PA2503885 – Officer report
(CA162B) 15 Delatite Lane and unallocated Crown land,
Mount Buller

Officer Assessment Report
Development Assessment

Department
of Transport
and Planning

Figure 1: Lower floor plan of proposed garage (Source: Application)

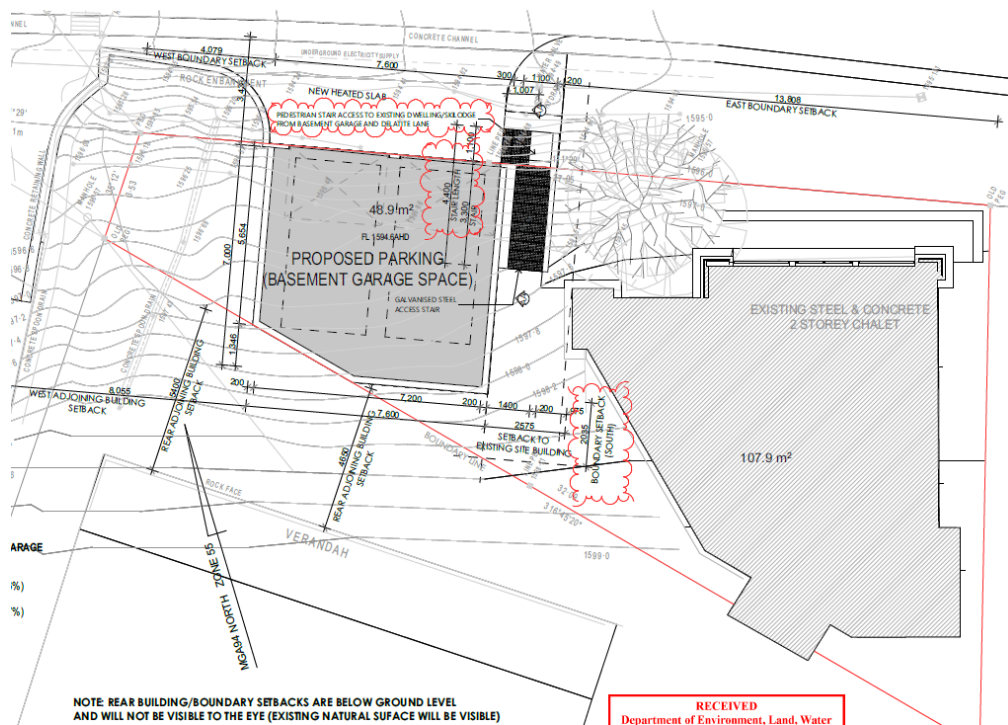
- The construction of an underground double garage with zero setbacks to Delatite Lane lease boundary and the rear (southern lease boundary). (Refer to Figures 1 & 2).
- Comprises 48.9 sqm.
- Earthworks (cut) comprising maximum 3.2m. (Refer to Figure 3).
- Garage doors comprise timber shiplap material in brown tones.

- Galvanised access stairs comprising 1m wide, 4.4 m long and a height of 2.6 m. (Refer to Figures 1, 2 and 4).
- Access stairs will provide pedestrian access to the existing lodge from the basement of the garage and Delatite Lane.
- Part of the access stairs is located within unallocated Crown land.

- The construction of a new retaining wall to merge with the existing retaining wall to the west side of the proposed garage. (Refer to Figures 1 and 2).
- Retaining wall constructed of natural stone.
- Part of the retaining wall is located within unallocated Crown land.

Figure 5: Landscaping/rehabilitation plan (Source: Application)

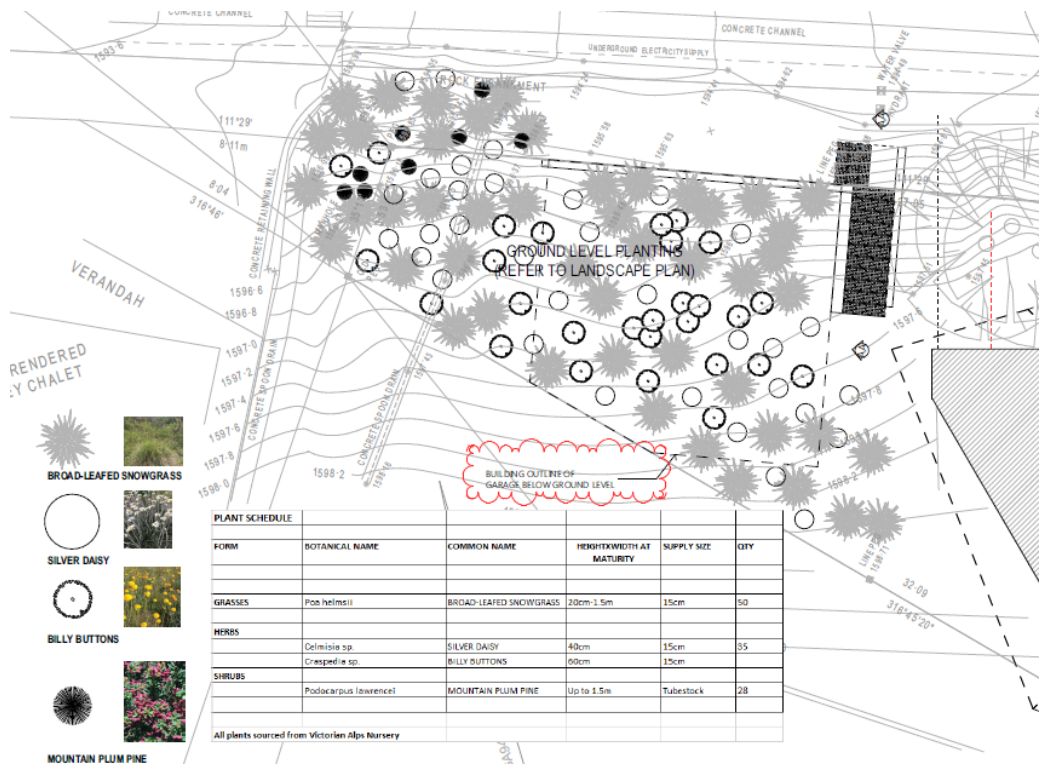
- No vegetation is proposed to be removed.
- Ground level to be rehabilitated/landscaped comprising small shrubs and grasses. (Refer to Figure 5).

43. The proposed external staircase will provide safe pedestrian access from the garage to the existing lodge.
44. The site where the garage will be located will be landscaped/rehabilitated with ground level planting consisting of small scale grasses and shrubs, suitable within the alpine area. The landscape plan forms part of the architectural plans and a condition of permit will require the land be rehabilitated in accordance with the plans.
